BAB SHAMS POLICE STATION  
MOSUL, IRAQ

SUSTAINMENT ASSESSMENT

**SIGIR PA-06-091**  
**APRIL 25, 2007**

SUBJECT: Report on Bab Shams Police Station Sustainment, Mosul, Iraq  
(Report Number SIGIR PA-06-091)

USACE Construction Photo 2 (12 Jun 05)

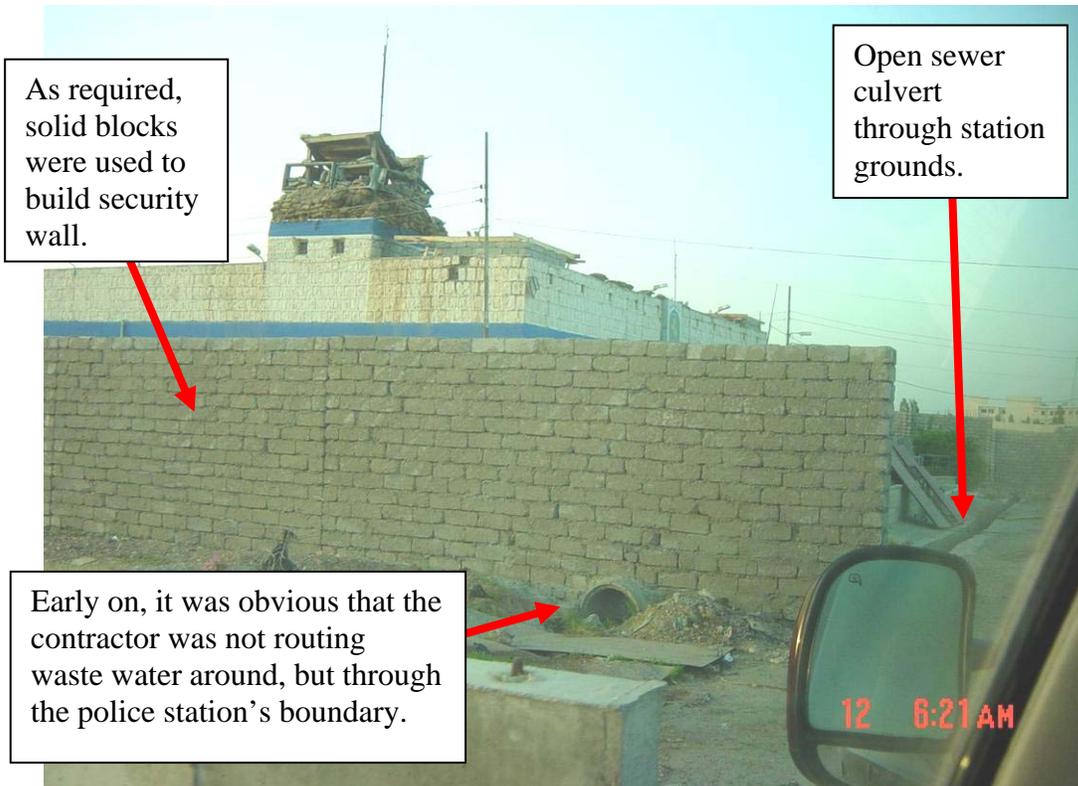
Contrary to SOW requirements, USACE Construction Photos 2 and 3 show that sewer water was not being routed around the perimeter of the police station, but through the station's boundaries. Issues related to the location of the sewer water conveyance system are addressed in the Site Assessment section of this report.

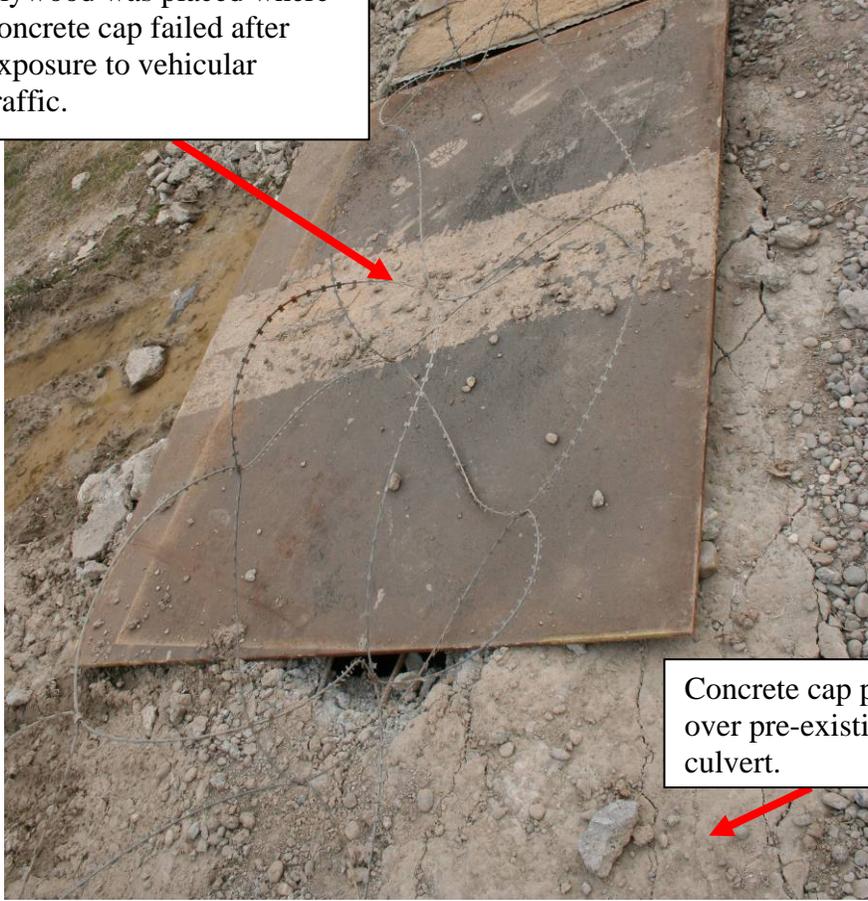
In the absence of any quality control (QC) or sufficient quality assurance (QA) reports and any design submittal and approval documentation within the information provided by USACE, SIGIR was not able to determine why contractor personnel proceeded, or were allowed to proceed, as they did. However, the contractor's intention not to route waste water around the perimeter should have been obvious to USACE personnel as early as 12 June 2007 when USACE Construction Photos 2 and 3 were taken.

Rather than route sewer water around the perimeter of the station, the contractor merely capped the pre-existing open culvert with concrete. SIGIR inspectors observed that the construction of the concrete cap was poor for a number of reasons and had collapsed under the weight of vehicle traffic (Site Photo 3). As shown in Site Photo 4, the concrete was not uniformly mixed, was cast too thin and was cast without rebar or wire to improve the tensile strength.

Concrete seemed to be brittle and crumbly to the touch. It was cast too thin, cast without rebar or reinforcement wire and not uniformly mixed.

Form design should have facilitated a concrete on concrete casting.

**Site Photo 6.** Outside the entrance, there was a sizeable area with sufficient slope to generate substantial runoff to IP station boundaries.

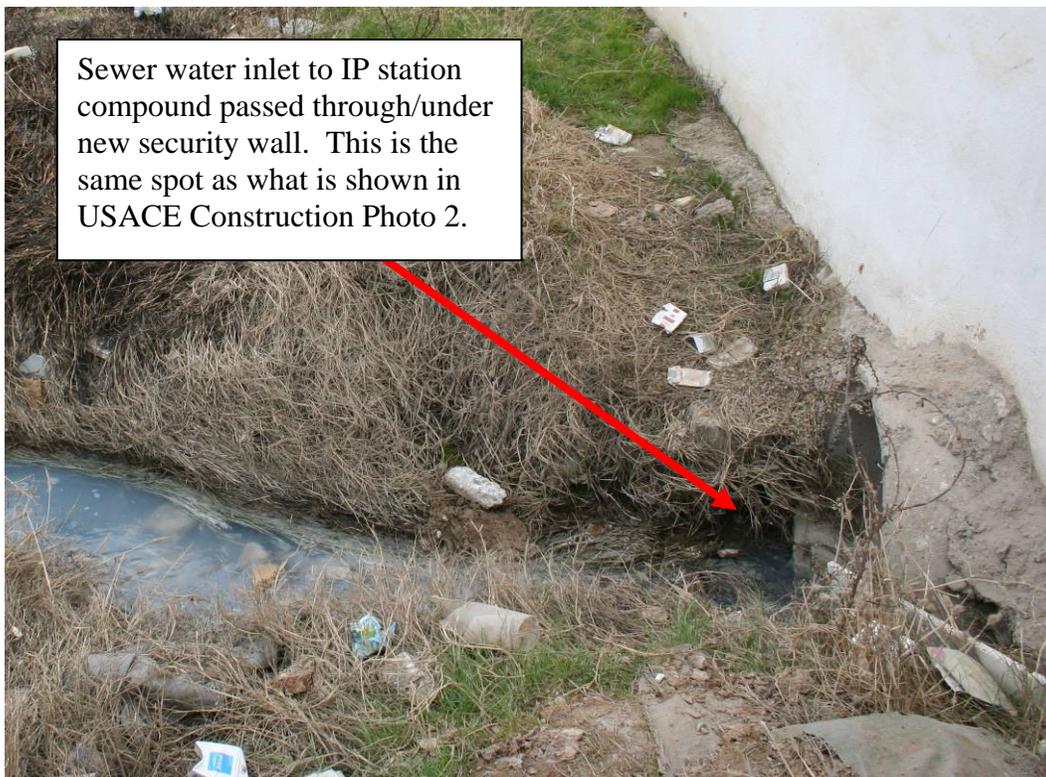
Before renovation, the chain linked fence (USACE Pre-Construction Photo 3) that surrounded the IP station did not impede runoff water. Conversely, the new solid block security wall (USACE Construction Photo 3 and Site Photo 5) on the low<sup>5</sup> side of the compound could block or impede the flow of rain water runoff and sewage water flow (Site Photo 6). The runoff from within the compound, combined with the regular sewer water flow and rain water runoff channeled into the station from outside the compound, could lead to standing water conditions within the compound.

At the time of the site inspection, the conditions were dry and not impacted by recent rains. Nevertheless, Site Photo 7 shows that the open culvert on the high side or half of the compound was running free and able to handle the waste water volume entering the compound that day. However, Site Photo 8 taken at the exit and the open culvert's lowest spot within the confines of the compound shows the open culvert nearly full. It would not take much rain water runoff to create a flooded condition within parts of the IP compound area.

Site Photo 9.

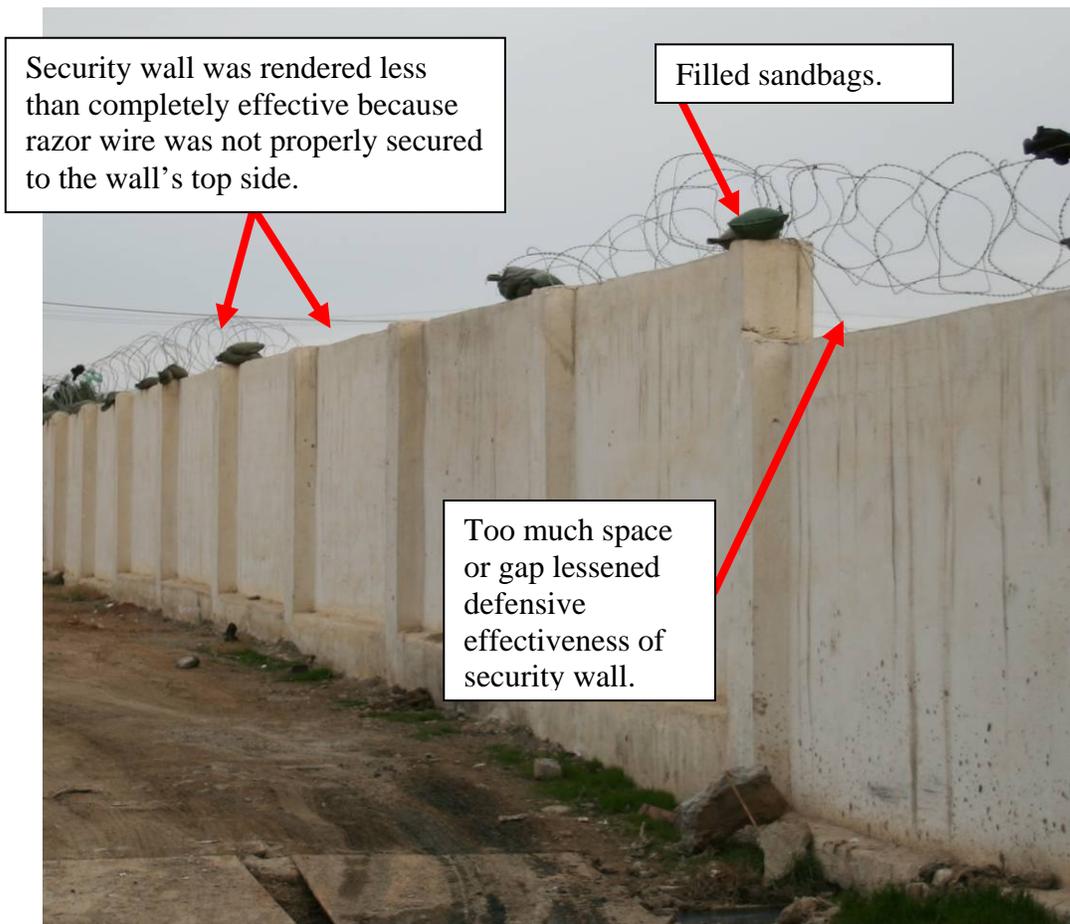
All requirements related to the construction of the security wall were met with the exception of the barbwire which was not adequately secured and placed on the top side of the wall. Site Photo 9 shows that the wire was merely held in place by sand bags that could be pushed or pulled off by personnel wanting to scale the wall. Without the sand bags in place, the wire does not stay in place atop the wall. In addition, the wire was stretched in such a manner that spaces or gaps between the wire and wall developed. SIGIR inspectors observed several places where the wire was not attached or placed in a manner that enhanced the defensive effectiveness of the security wall.

A review of the USACE final inspection report dated 23 September 2005, disclosed that the wire for the top of the perimeter wall was not installed and was “still piled up on the ground where it was unloaded from the delivery truck”. USACE officials were aware of

Site Photo 14.

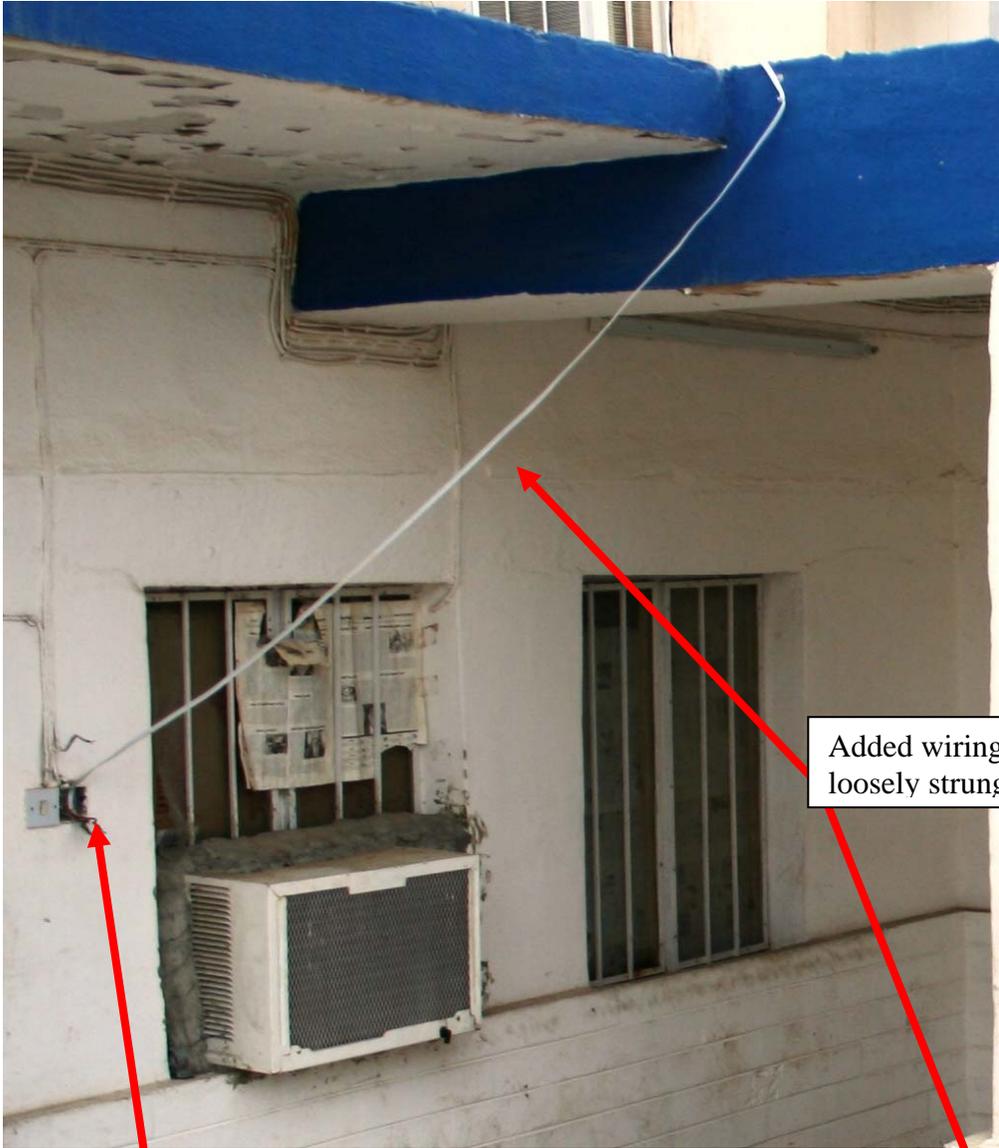
In Site Photos 14 and 15 a typical form of tampering observed by SIGIR inspectors is shown. Site Photo 14 shows how added wiring was loosely strung. Site Photo 15 is a close up and it shows the technique used to “tap into” an existing circuit. Specifically, the existing circuit and load requirement was maintained by twisting the wiring together in order to close the existing circuit. However, the “jury-rigged” wiring that fed a draw point only added to the circuit’s potential load or draw.

Added wiring was loosely strung.

Site Photo 15.

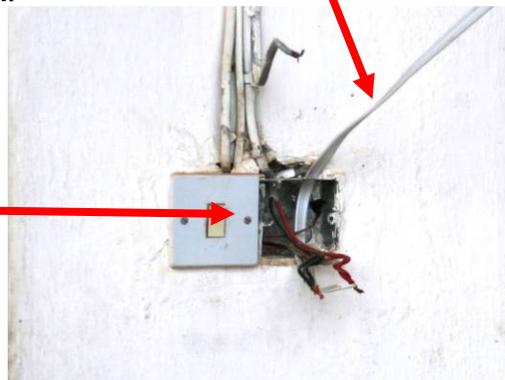
Switch or plug-in was removed and added wiring "tapped into" the circuitry.

**Site Photo 16.**

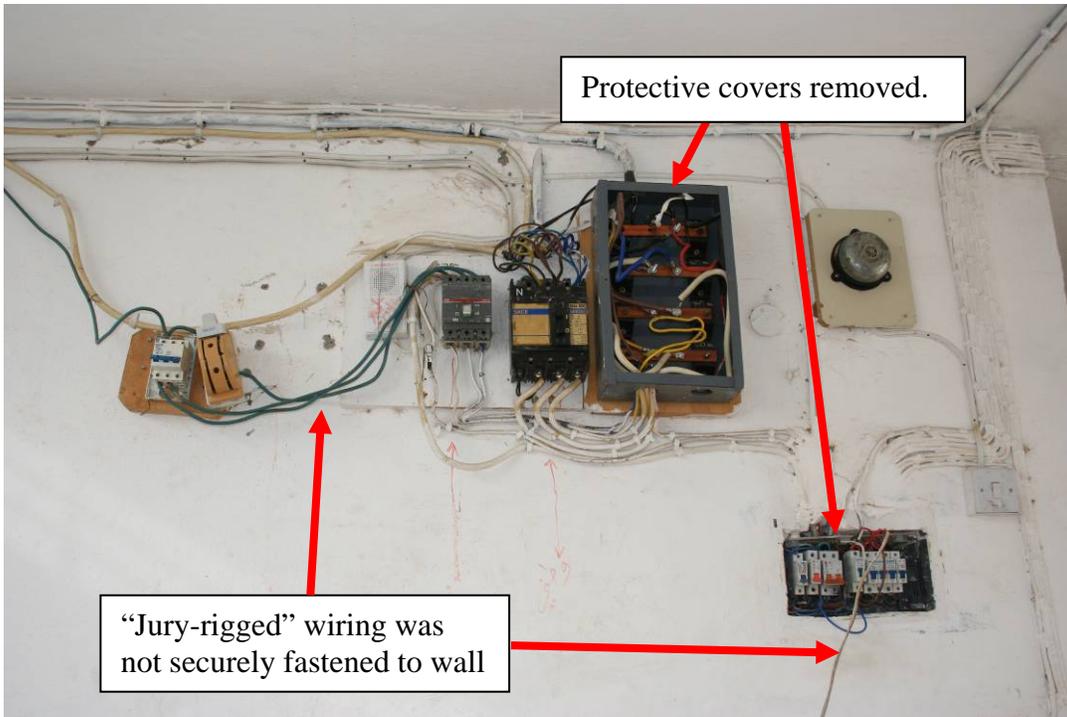
- USACE Construction Photo 5 shows where the contractor added electric system upgrades and properly covered and secured wiring. Conversely, Site Photo 16 taken at the same spot shows where covers were removed and energized system components were exposed. In addition, the photograph shows that “jury-rigged” wiring was added and not secured to walls.
